ADDENDUM NO. 2

This Addendum contains changes to the requirements of the Bidding Documents, Technical Specifications and Construction Drawings, which have been issued to date. Such changes are to be incorporated into the Construction Documents and shall apply to the Work with the same meaning and force as if they had been included in the original documents. Wherever this Addendum modifies a portion of a paragraph of the Project Manual, or portion of any Drawings, the remainder of the paragraph or Drawing shall remain in force;

Upgrade AHU & Ventilation System
LoGrasso Hall
261 Temple St., Fredonia NY 14063
SUNY Fredonia Project No. 051039

1
SK-A3

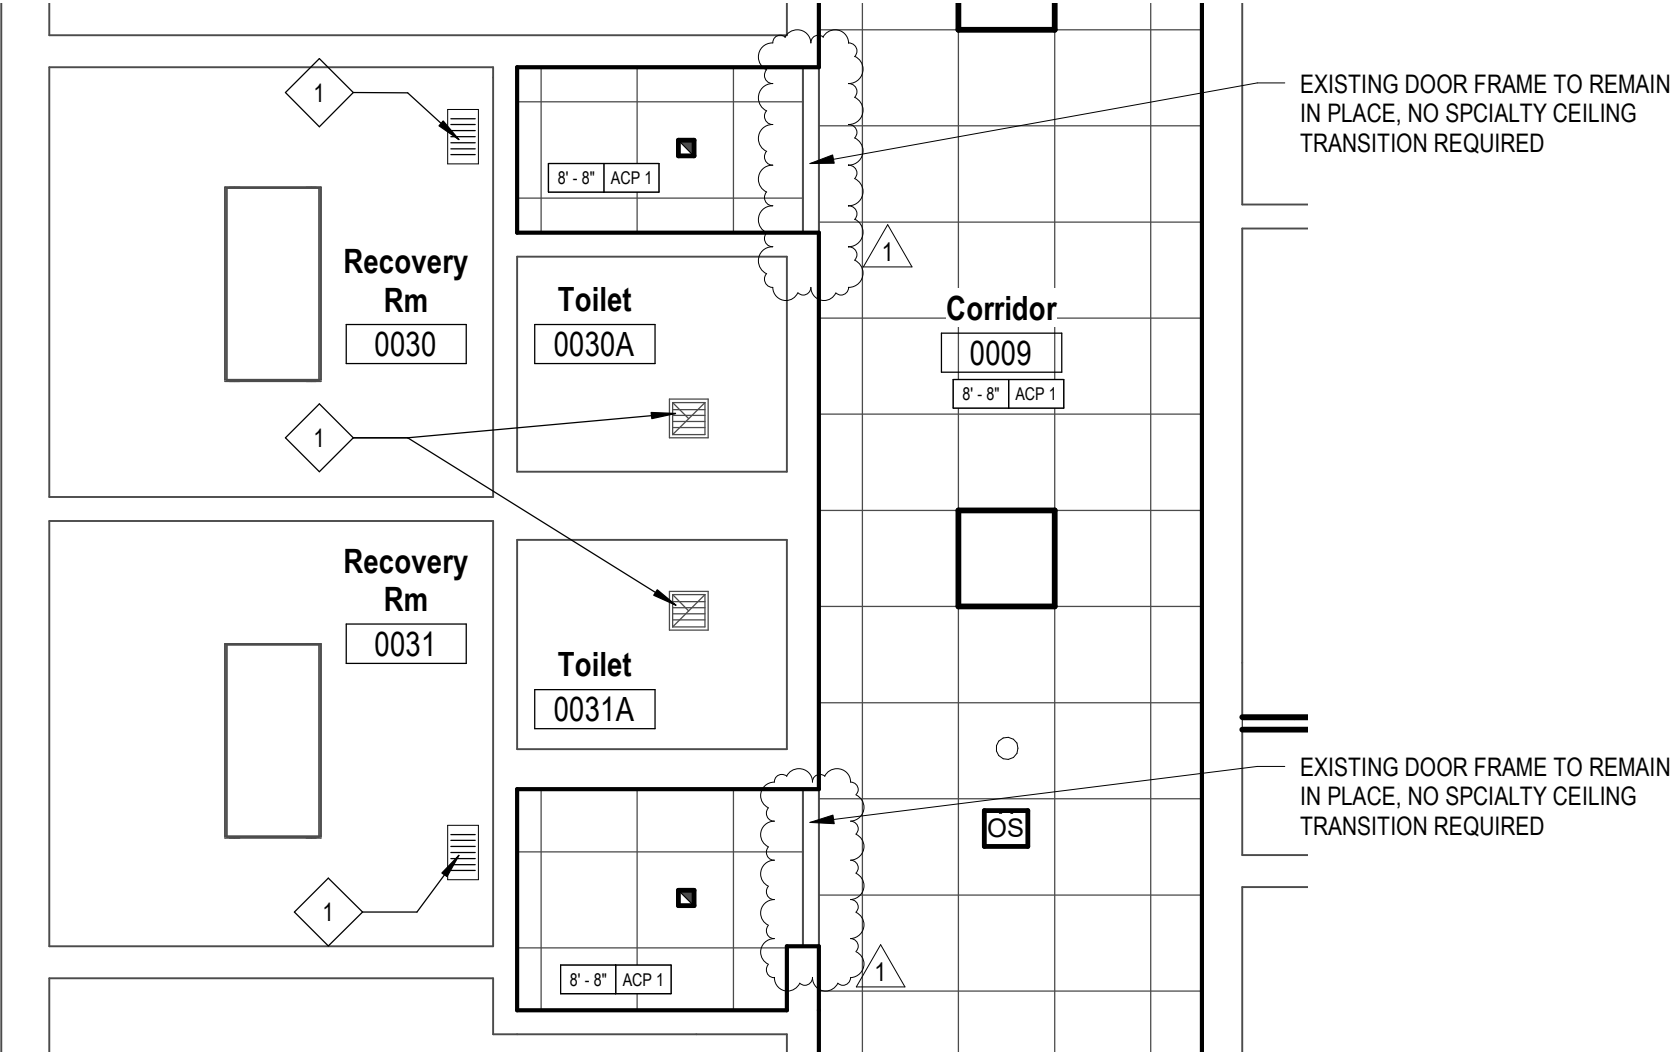
3. Drawing A110 – CEILING ALTERATION PLANS.

- a. REVISE Plan 1 to illustrate existing to remain door frames at hallways leading from Corridor 0009 to Recovery RMs 0031 and 0030 in place of planar ceiling transition.

DRAWING No.:
SK-M1
DRAWING REFERENCE No.:
M801

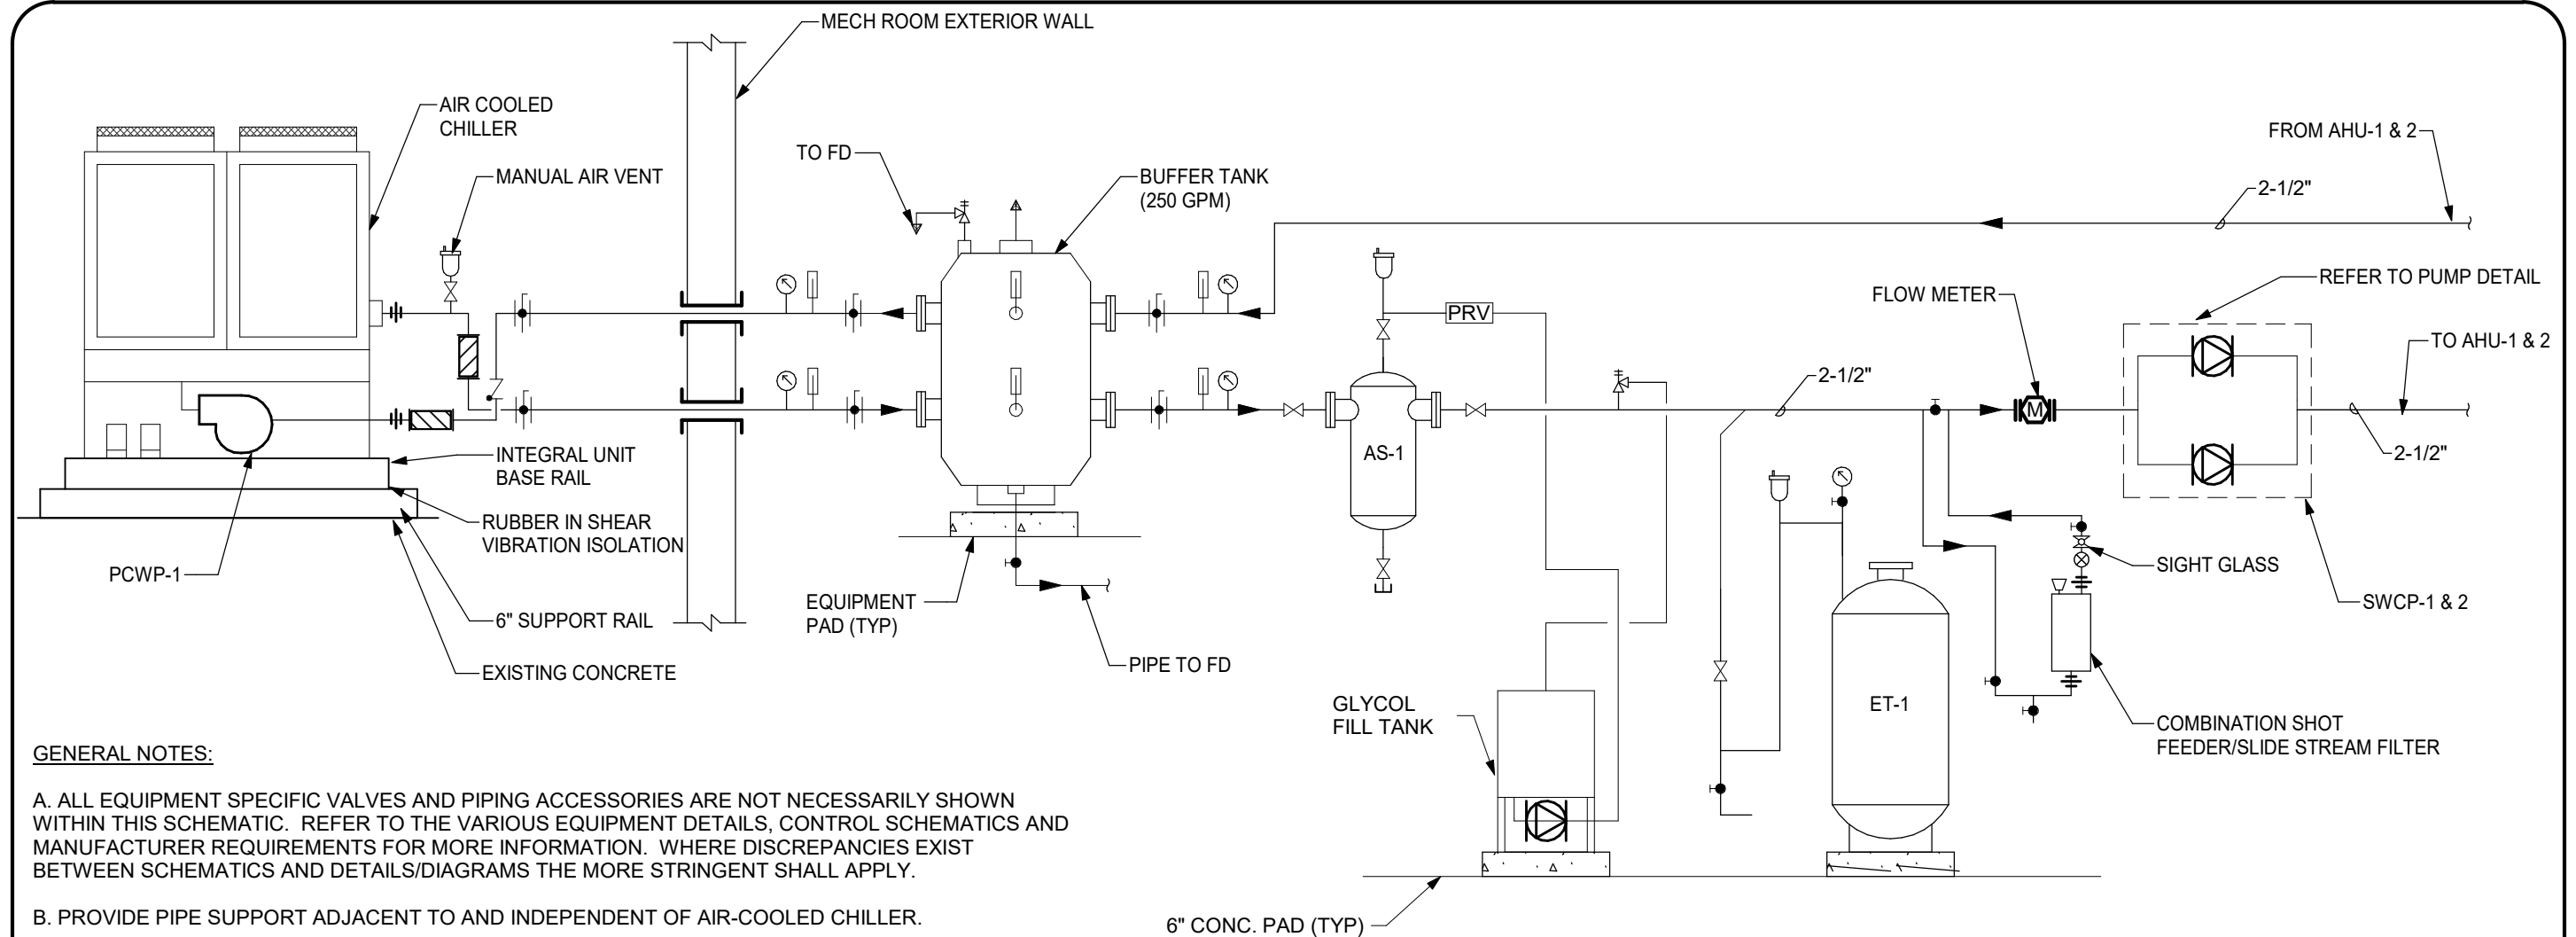
8. Drawing M801 - Control Schematics - HVAC.

- a. REVISE Detail 4 as depicted on SK-M1, attached hereto.
